ARLINGTON AVENUE BRIDGES REPLACEMENT

Design Review Committee Meeting #8 | December 13, 2022

South Bridge Riverwalk Impacts

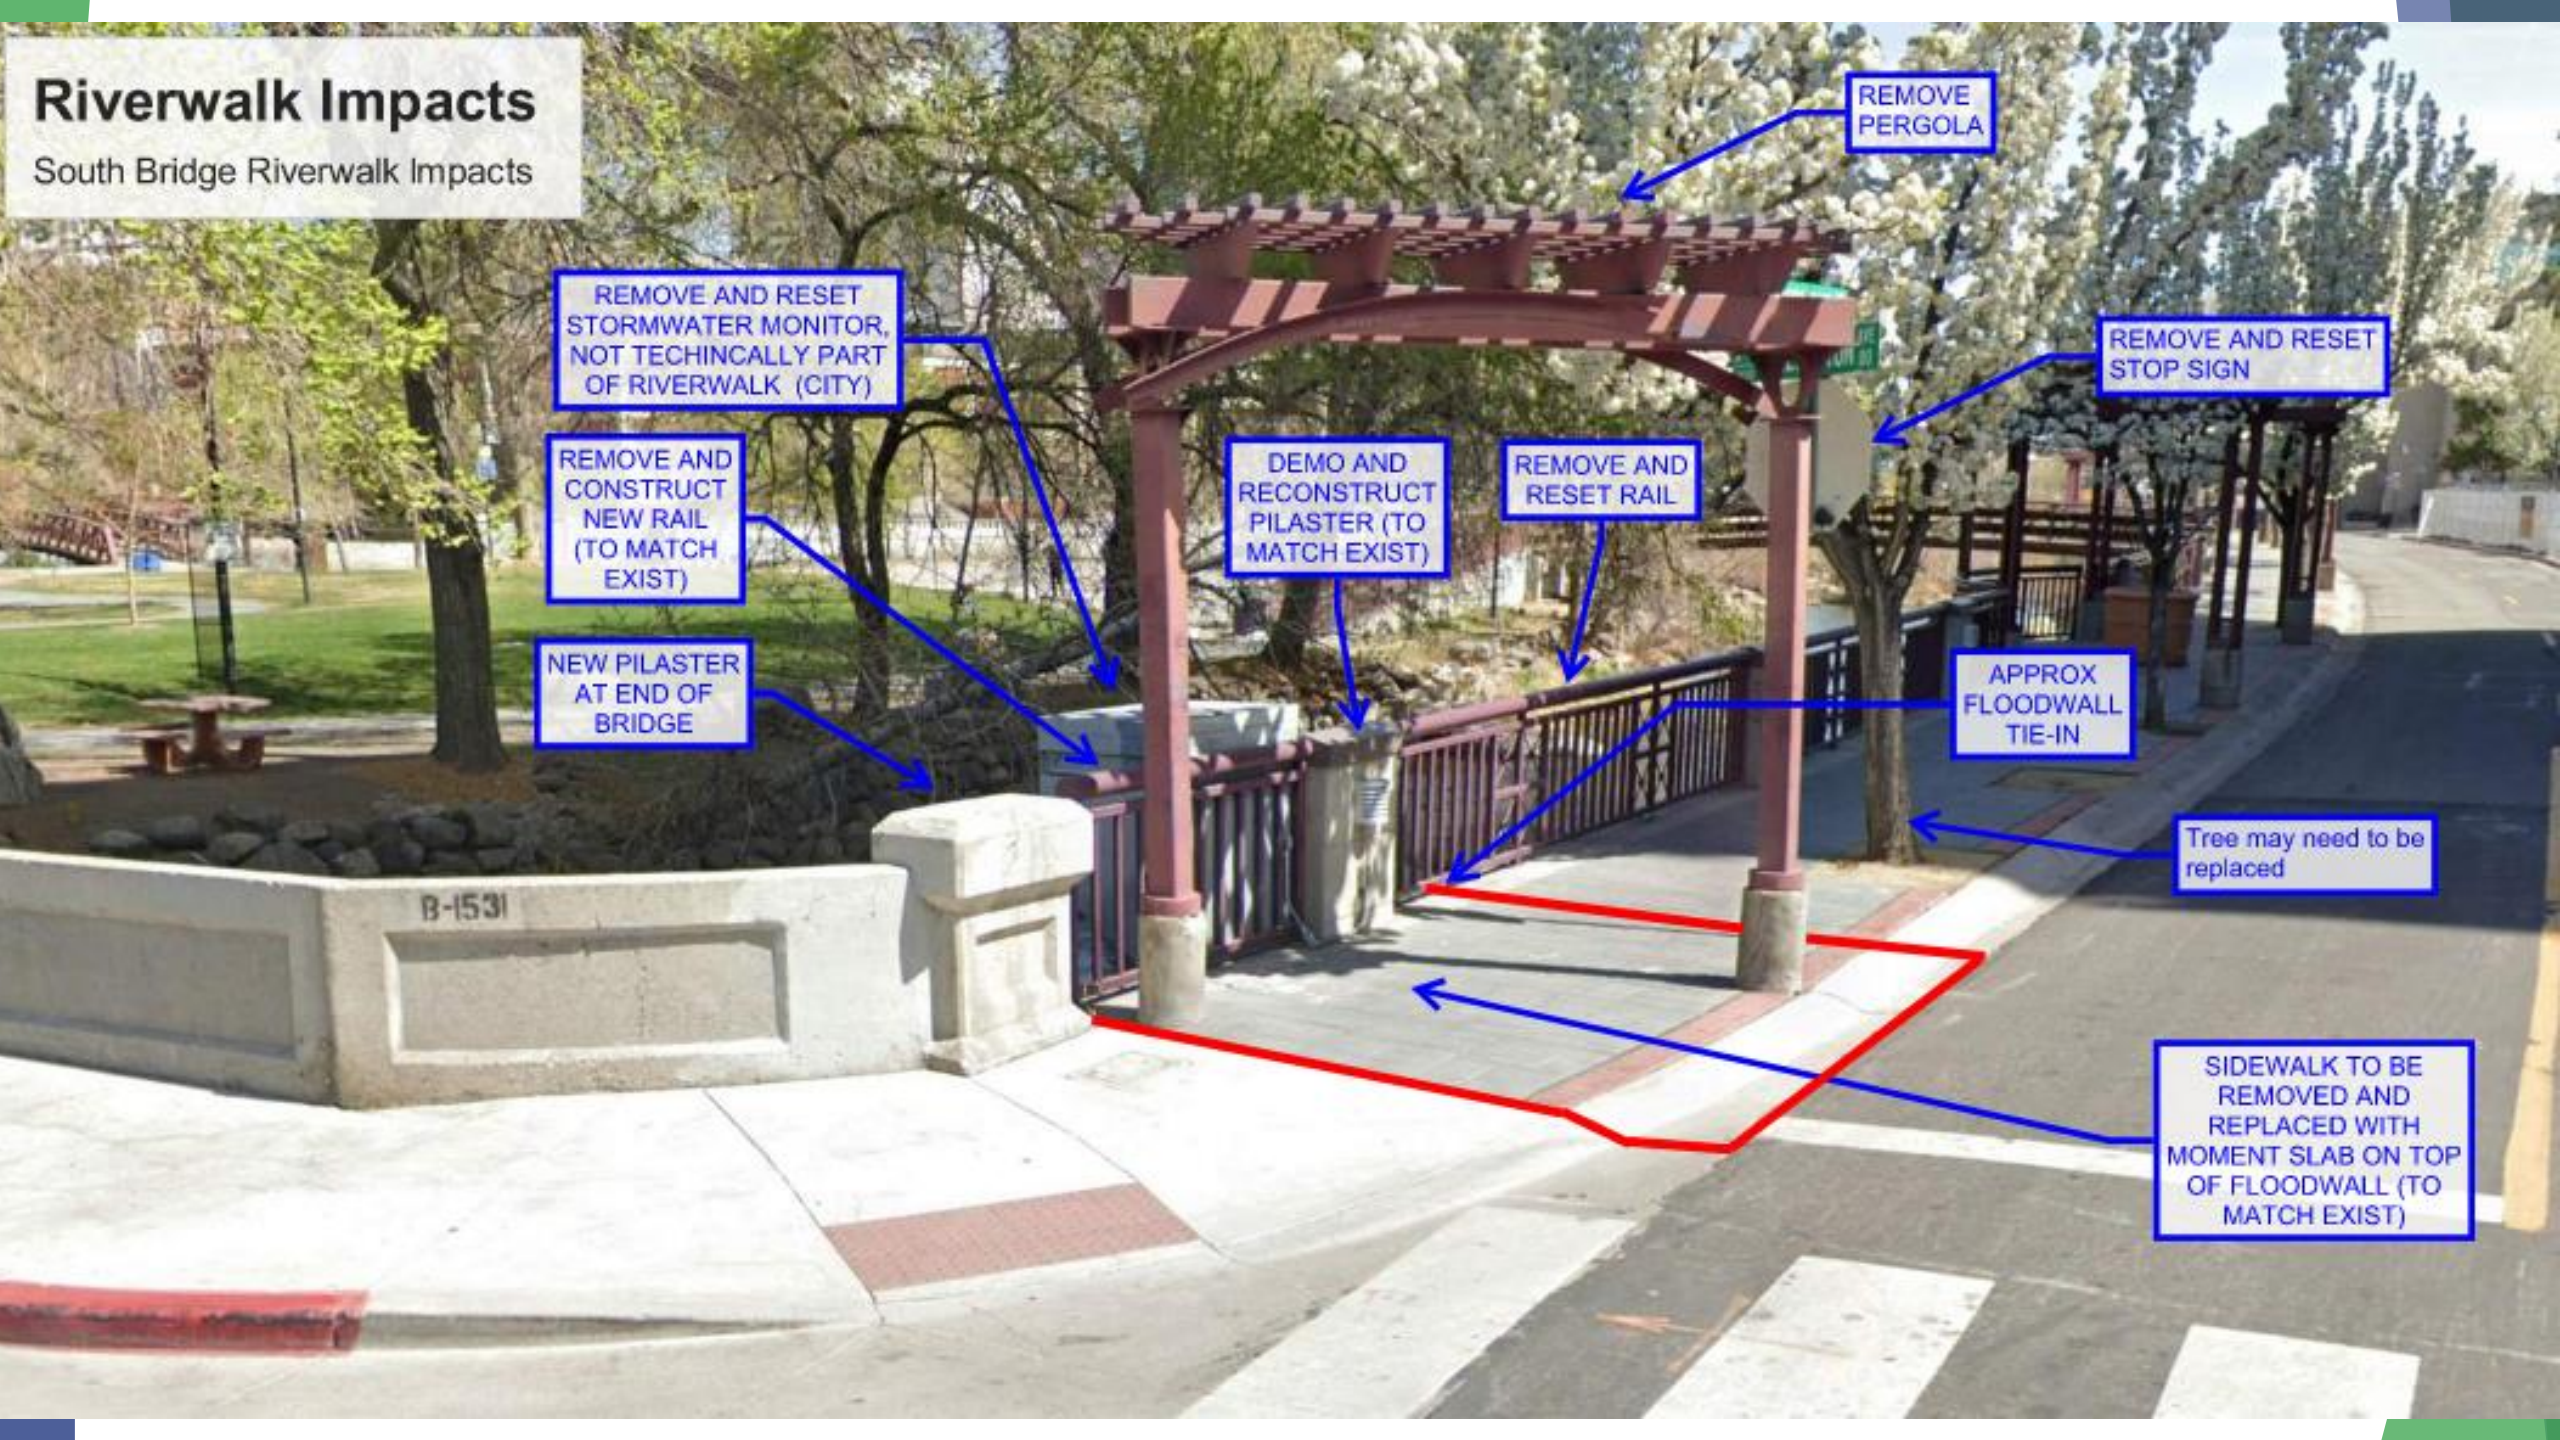
REMOVE PERGOLA

REMOVE AND RESET STOP SIGN

REMOVE AND RESET STORMWATER MONITOR, NOT TECHINCALLY PART OF RIVERWALK (CITY)

REMOVE AND CONSTRUCT NEW RAIL (TO MATCH EXIST)

DEMO AND RECONSTRUCT PILASTER (TO MATCH EXIST)

REMOVE AND RESET RAIL

APPROX FLOODWALL TIE-IN

NEW PILASTER AT END OF BRIDGE

Tree may need to be replaced

North Bridge Riverwalk Impacts
(NE Corner)

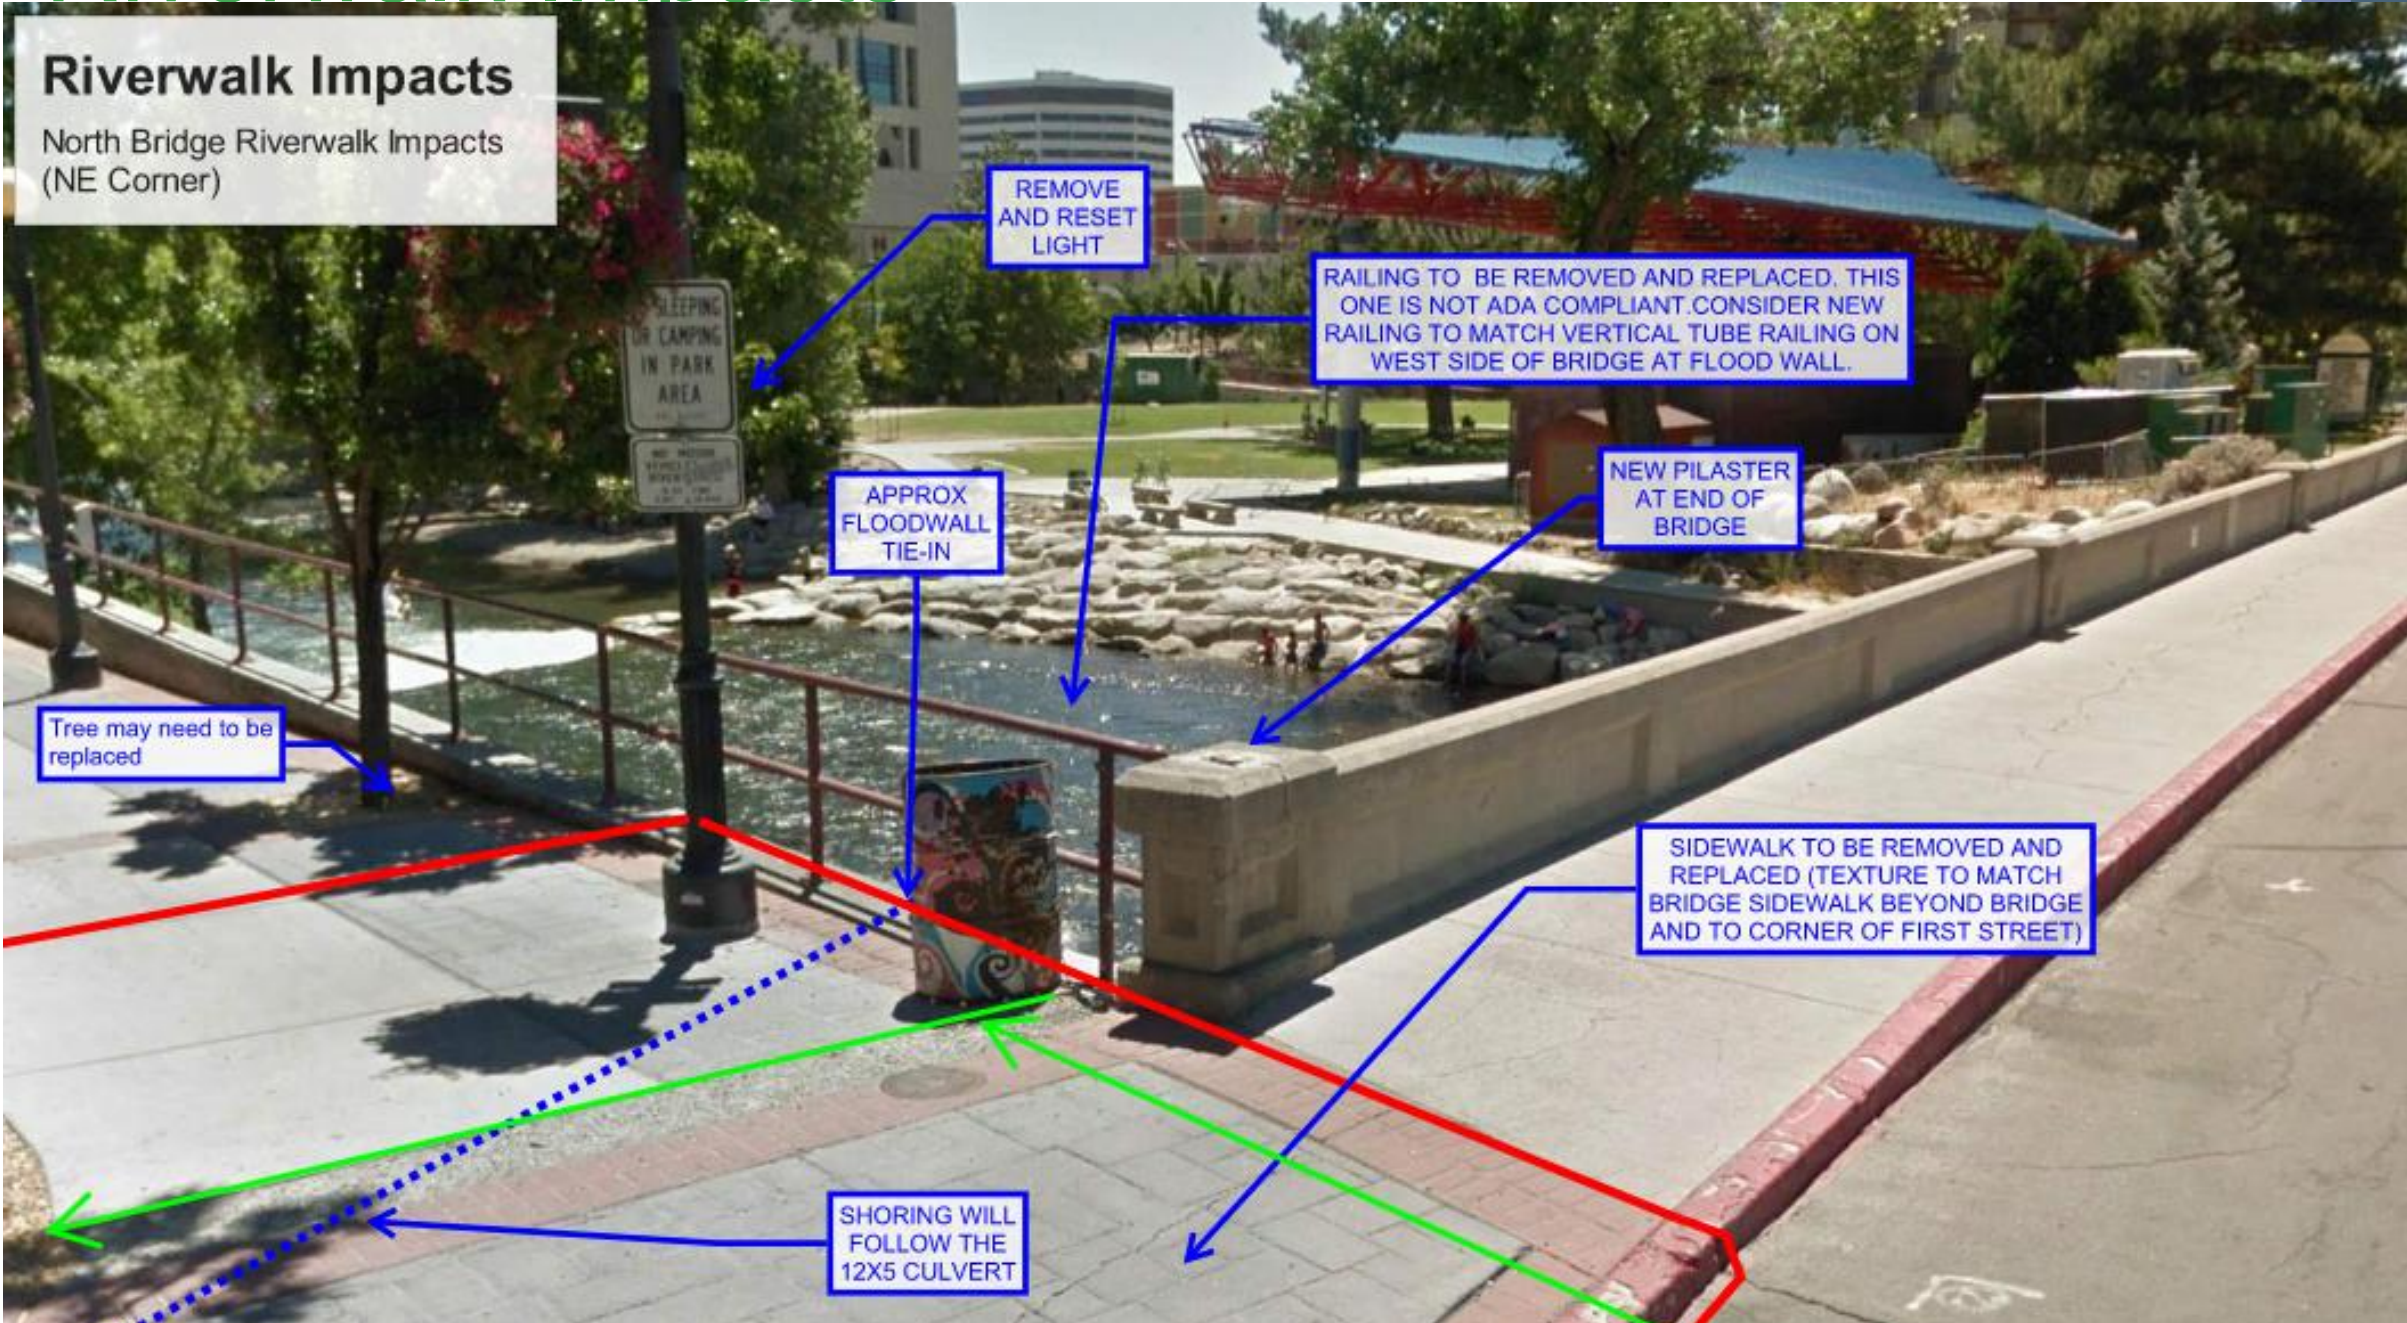
SIDEWALK TO BE REMOVED AND REPLACED WITH MOMENT SLAB ON TOP OF FLOODWALL (TO MATCH EXIST)

REMOVE AND RESET LIGHT

RAILING TO BE REMOVED AND REPLACED. THIS ONE IS NOT ADA COMPLIANT. CONSIDER NEW RAILING TO MATCH VERTICAL TUBE RAILING ON WEST SIDE OF BRIDGE AT FLOOD WALL.

NEW PILASTER AT END OF BRIDGE

SIDEWALK TO BE REMOVED AND REPLACED (TEXTURE TO MATCH BRIDGE SIDEWALK BEYOND BRIDGE AND TO CORNER OF FIRST STREET)

SHORING WILL FOLLOW THE 12X5 CULVERT

North Bridge Riverwalk Impacts
(NW Corner)

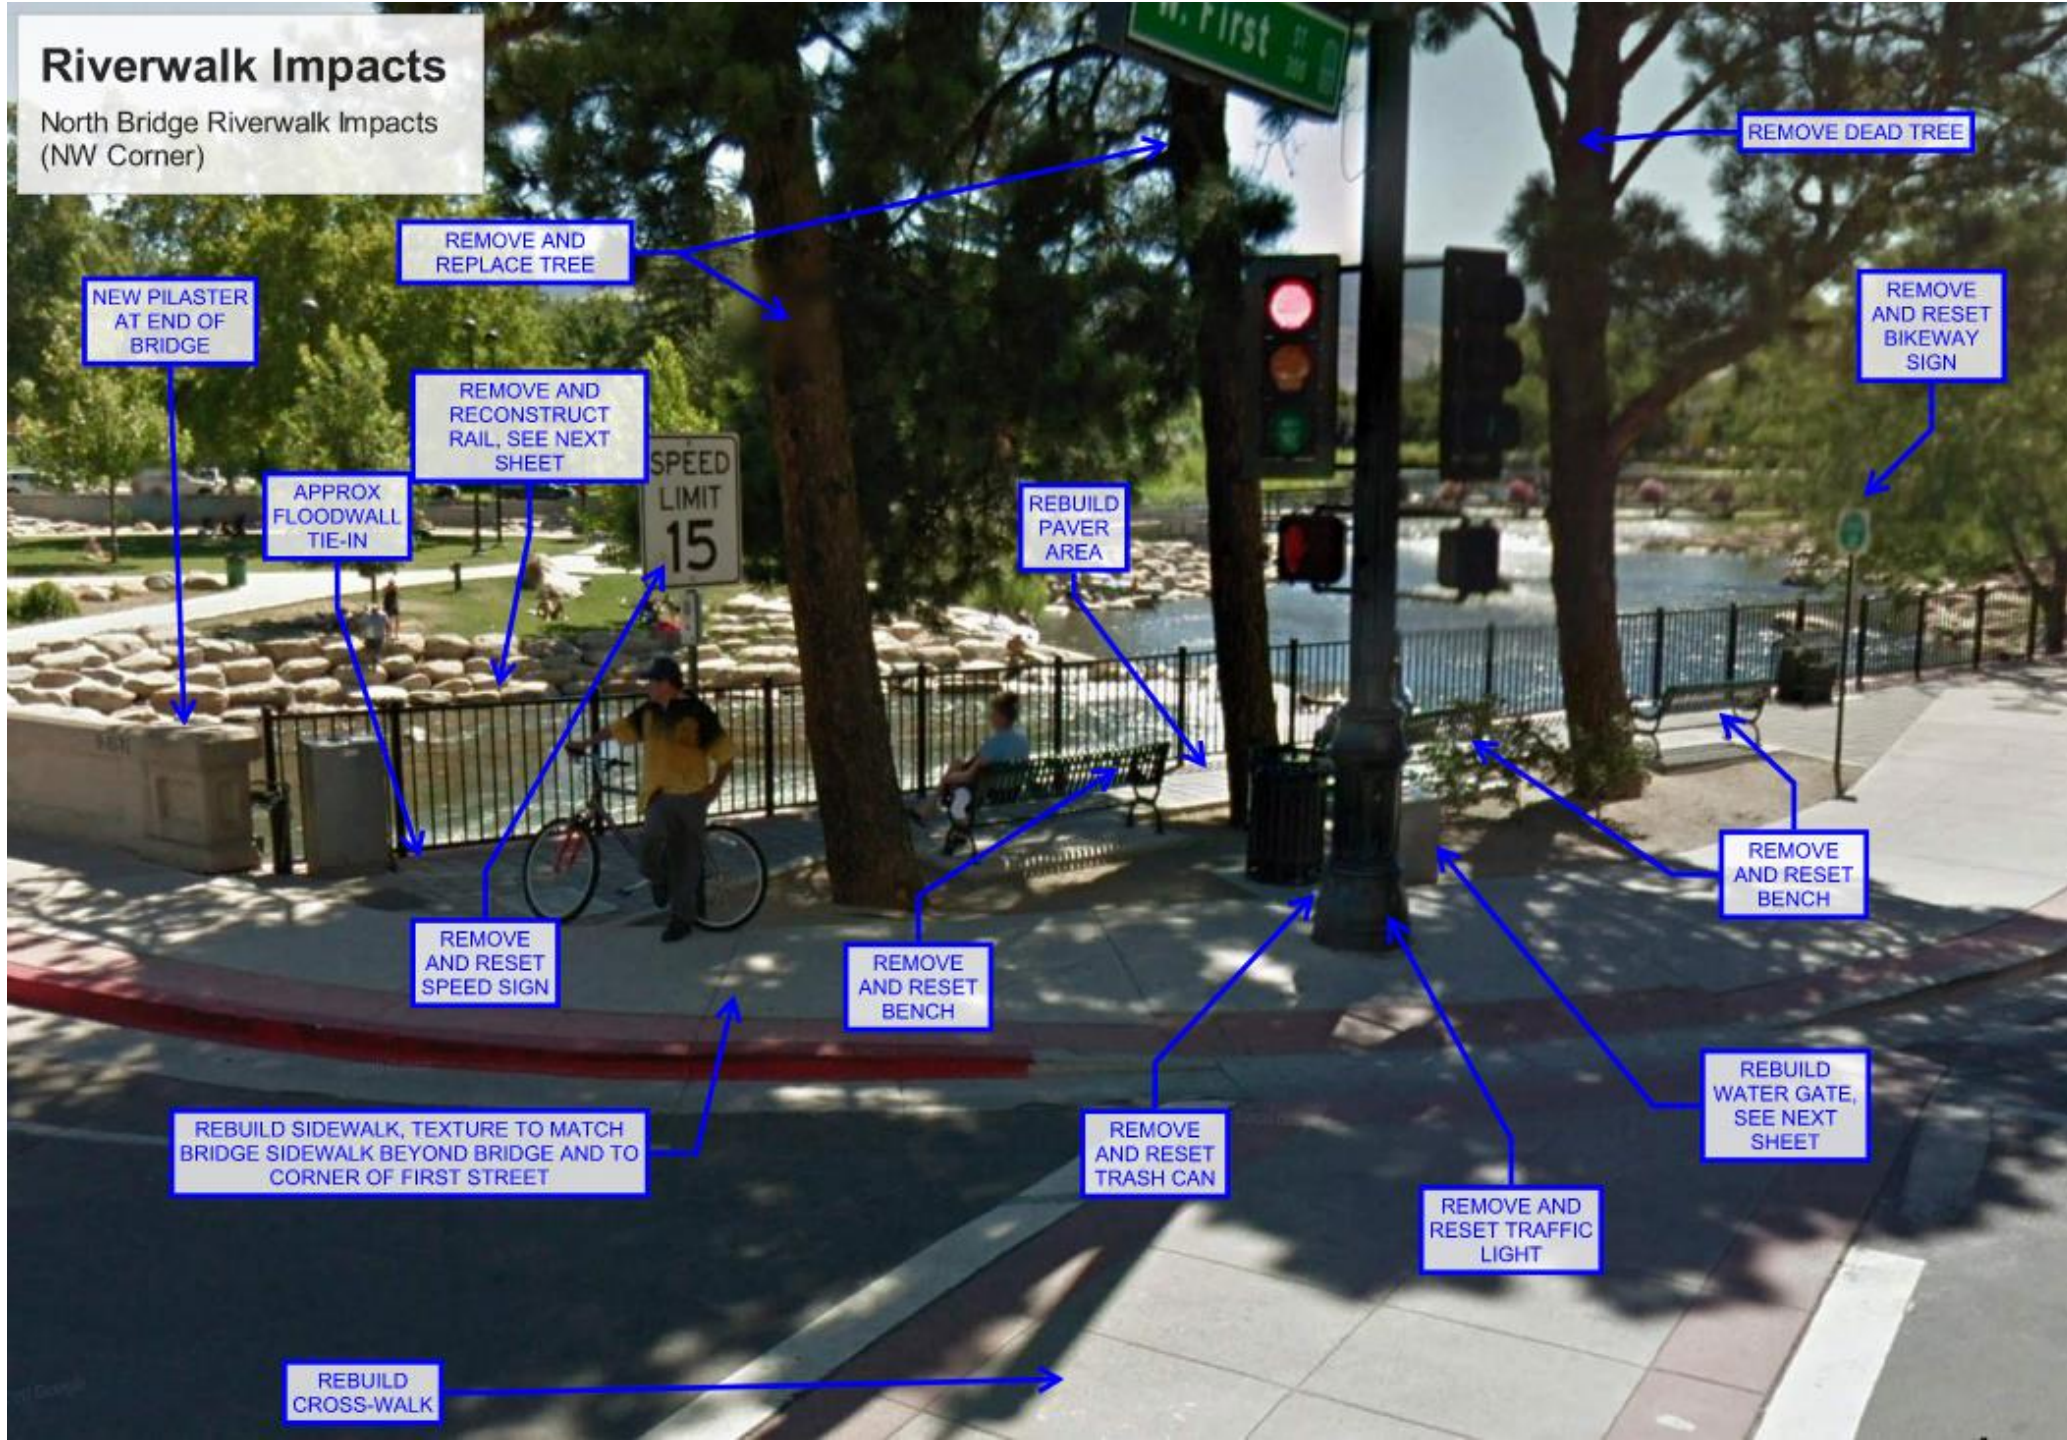
APPROX FLOODWALL TIE-IN

Tree may need to be replaced
